**Model
Administrative Change Notice**

1. Document Number:	ANL-EBS-MD-000027	2. Revision:	03	3. ACN:	02
4. Title:	Drift Degradation Analysis				
5. No. of Pages Attached	20

Figure 6-2. Geology of the Central Block at Yucca Mountain and Location of the ESF, Including the ECRB Cross-Drift

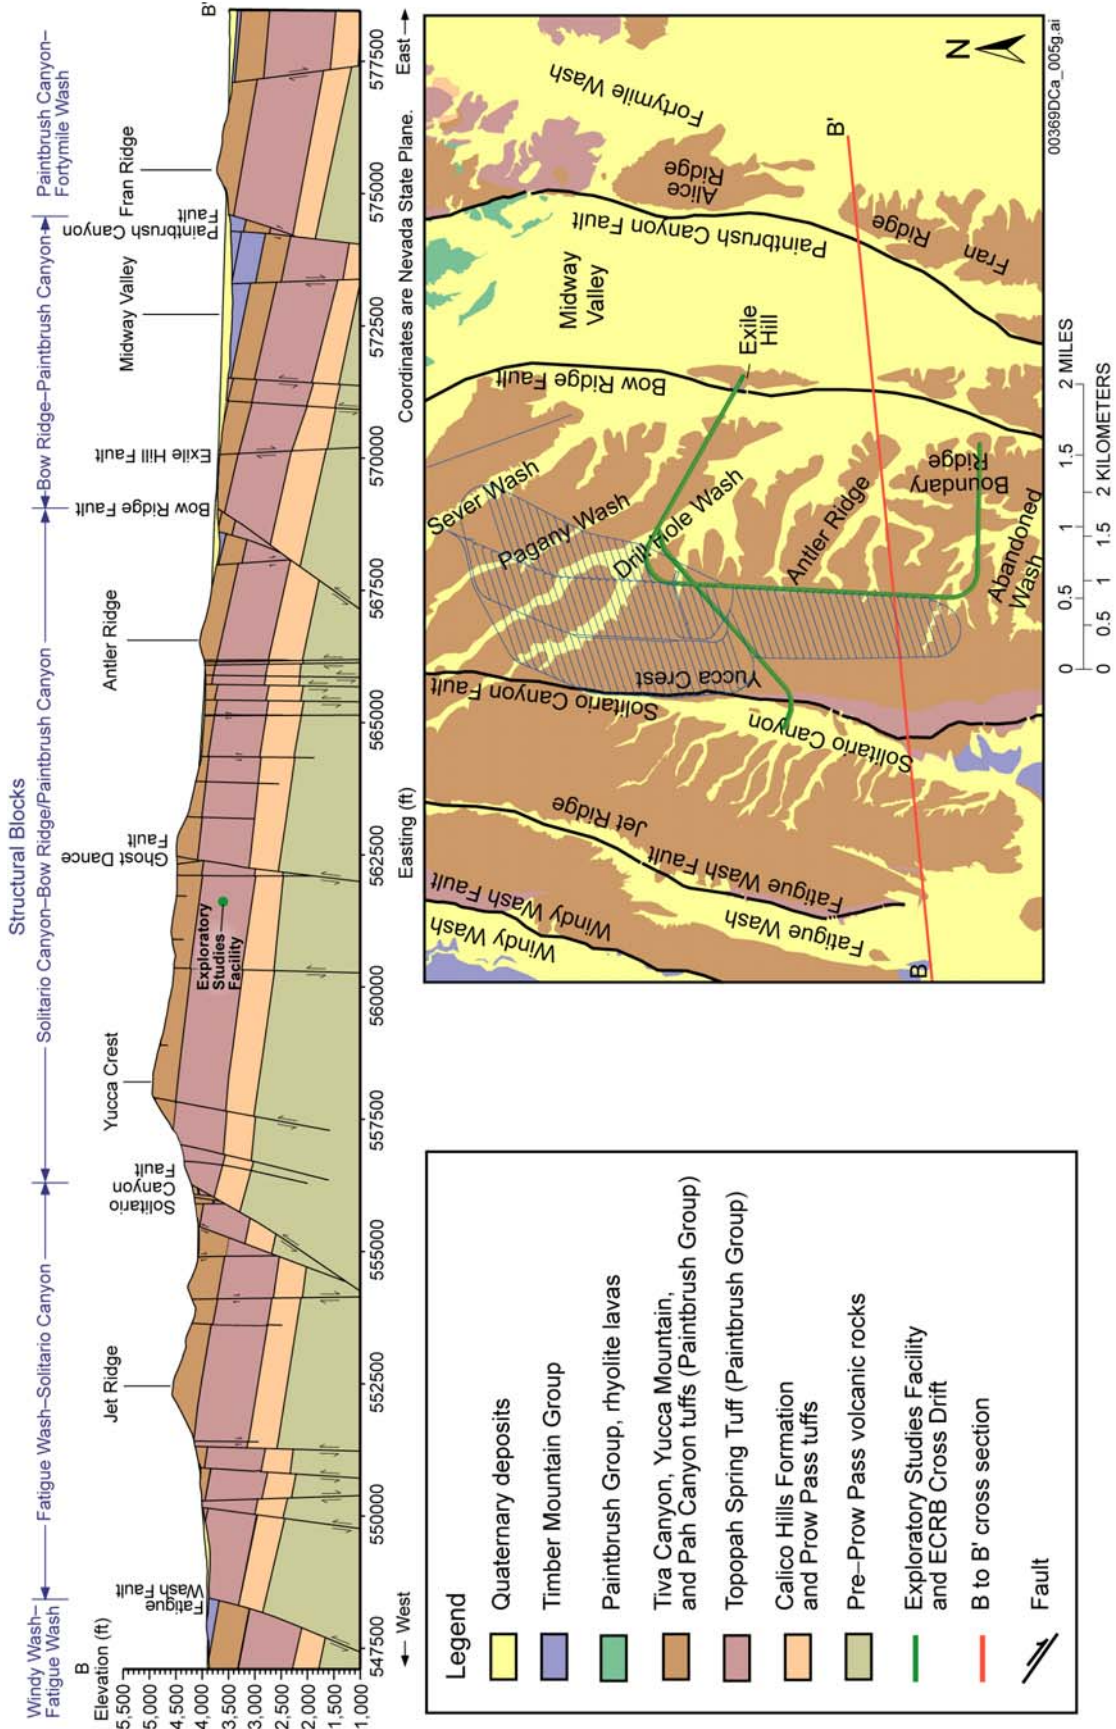
6-5	<p>Self-identified correction on page 6-5, first paragraph.</p> <p>“The central block of Yucca Mountain is bounded by the Yucca Wash to the north, by the Solitario Canyon fault to the west, and the Bow Ridge fault to the east (Figure 6-2).”</p> <p>is modified to read,</p> <p>“The central block of Yucca Mountain is bounded by the Solitario Canyon fault to the west, and the Bow Ridge fault to the east (Figure 6-2).”</p>				
6-6	<p>Self-identified correction on page 6-6, Figure 6-2 contained text that was illegible.</p> <p>The figure has been replaced to clarify the illegible text.</p> <p>Note: The new figure is based on the same source as the replaced figure and has no impact on the results of the Drift Degradation Analysis report.</p>				
6-11	<p>Self-identified correction on page 6-11, text within Figure 6-4 was changed to correct a typographical error.</p> <p>The abbreviation for Middle Nonlithophysal was “Ttptll” and corrected to “Ttptmn”.</p> <p>Note: There were no other changes to the figure and the change has no impact on the results of the Drift Degradation Analysis report.</p>

The central block of Yucca Mountain is bounded by the Solitario Canyon fault to the west, and the Bow Ridge fault to the east (Figure 6-2). Alluvium-filled structural valleys, consisting mostly of alluvial fan deposits (fluvial and colluvial sediments) and some thin eolian deposits, lie adjacent to the Bow Ridge and Solitario Canyon faults on the east and west sides, respectively. The Yucca Mountain area is cut by steeply dipping, north-south-striking normal faults, which separate the Tertiary volcanic rocks into blocks one to four km wide (Scott 1990 [DIRS 106751]; Day et al. 1998 [DIRS 100027]). The Solitario Canyon and Ghost Dance faults dip steeply toward the west, and displacement, amount of brecciation, and number of associated splays vary considerably along their trace (Scott and Bonk 1984 [DIRS 104181]; Day et al. 1998 [DIRS 100027]). The Solitario Canyon fault has normal down-to-the-west displacement of about 260 m in the vicinity of the repository block (Mongano et al. 1999 [DIRS 149850], p. 60). The Ghost Dance fault is in the central part the repository block and is a generally north-striking normal fault zone, with down to the west displacement. The Sundance fault is located in the north-central portion of the repository block. It is a northwest-striking, east-dipping normal fault with a maximum cumulative down-to-the-northeast displacement of 6 to 11 m (Day et al. 1998 [DIRS 100027]). Numerous smaller faults and fault zones are present throughout the repository block, generally north-trending with offsets less than 5 m (Mongano et al. 1999 [DIRS 149850]).

Figure 7-21. Numerical Experiment, Category 1: Failure Envelope

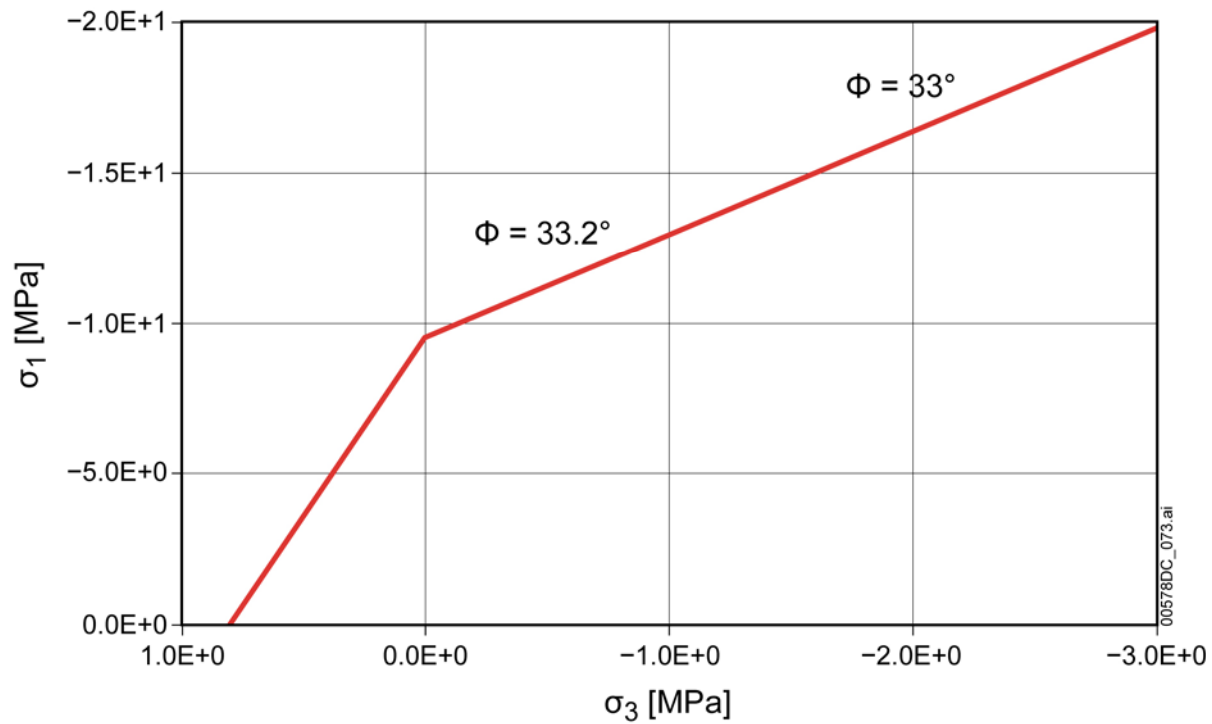
7-39	<p>This change is associated with CR-5600.</p> <p>Figure 7-21 “Numerical Experiment, Category 1: Failure Envelope”, on page 7-39 has been replaced to correct typographical error on the legend of the figure.</p> <p>Note: This change to the figure has no impact on the results of the Drift Degradation Analysis report.</p>				
9-22	<p>Reference information is added to Section 9.4. This is a self-identified correction.</p> <p>“MO0014RIB00035.001. Rock Thermal Expansion. Submittal date: 04/07/2000. 153848”</p>				
C-9	<p>Self-identified correction on page C-9, last paragraph, first sentence,</p> <p>“The heat capacity data used in the thermal property calculation (Table C-4) were preliminary data superseded by DTN: SN0307T0510902.003 [DIRS 164196] (Table E-19).”</p> <p>is modified to read,</p> <p>“The specific heat data used in the thermal property calculation (Table C-4) were preliminary data superseded by DTN: SN0307T0510902.003 [DIRS 164196] (Table E-19).”</p>
